AURIX™ TC36x errata sheet

Marking/Step: (E)ES-AA, AA

10592AERRA

Figure 15 Package Outlines TQFP-144 for TC36x

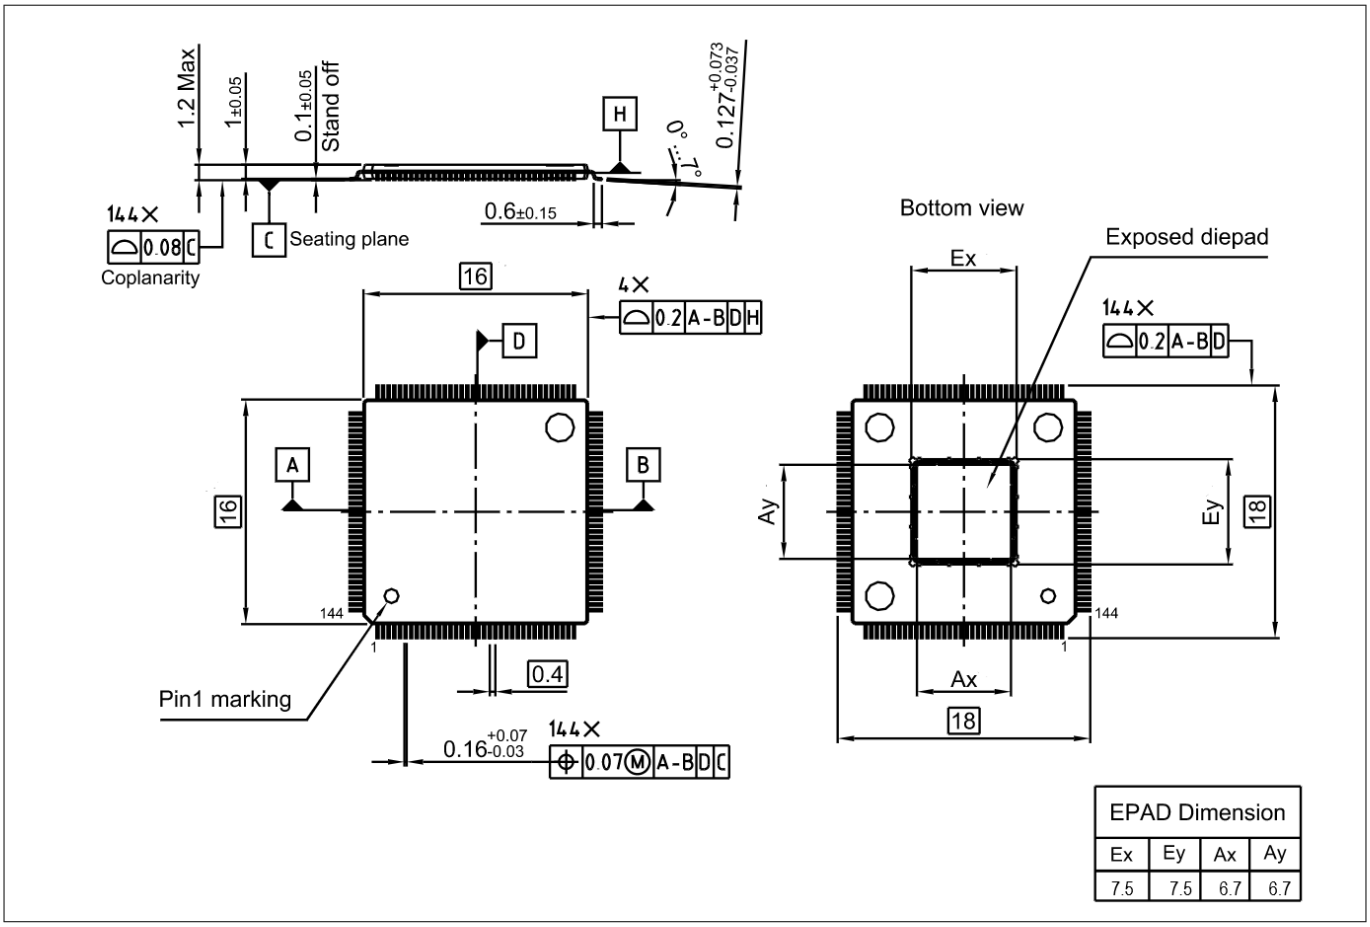
The dimensions for the exposed diepads have been corrected and included into the respective figures. This replaces the corresponding information in erratum text module PADS_TC.P013 (Exposed pad dimensions for QFP packages - Correction to TC36x Data Sheet V1.1).

***Note**: For the exposed diepad of the TQFP-144 package of the TC36x, structural corner protrusions have to be considered for purposes of system design and integration with a maximum boundary of 8.0 mm.*

Figure 16 Positive overload on P-pad of a LVDS RX pin pair (both used as inputs)

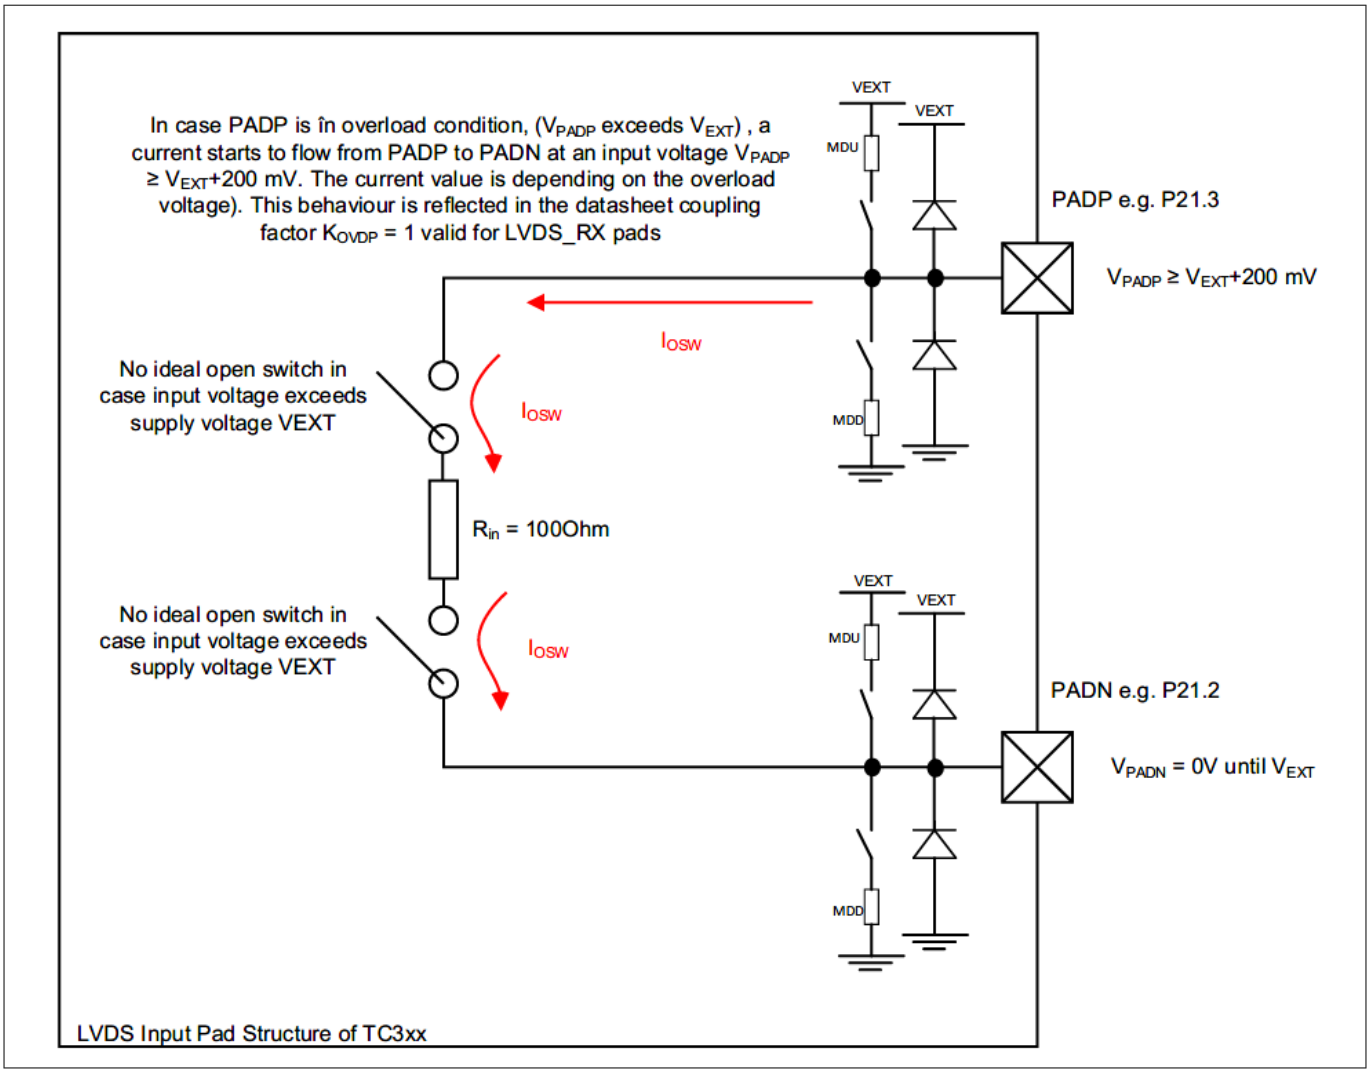
The following figure illustrates the effect for a positive overload condition ($V_{PADP} > V_{EXT}$) on the P-pad (PADP) of a pin pair where both the P-pad and the corresponding N-pad (NPAD, with $0V \le V_{NPAD} \le V_{EXT}$) are used as digital CMOS inputs.

The overload current I_{OSW} through the non-ideal open switch significantly increases when $V_{PADP} \ge V_{EXT}$ + 200 mV.

***Note**: In general, the effect will also occur if the N-pad is used as output, or for a negative overload condition on either the P-pad or the N-pad.*
